VKPC 81215 – OE/SKF Water pump design evolution

SEAT Arosa, Cordoba, Ibiza II/III 1.0, 1.4
VW Caddy II, Polo, Lupo 1.0, 1.4

OE Nb: 030 121 008 C, 030 121 005 S

VKPC 81215

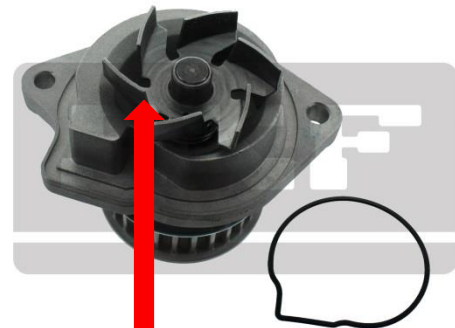
In compliance with an OE Design evolution, SKF has changed the design of the water pump kit VKPC 81215 from batch code 064N. The design evolution is impacting the impeller and gasket material. This evolution is also impacting all associated SKF Timing belt and water pump kits: VKMC 01106-1 and VKMC 01107.

- Plastic impeller
- Paper gasket

OLD DESIGN

- Steel impeller
- Rubber gasket

NEW DESIGN
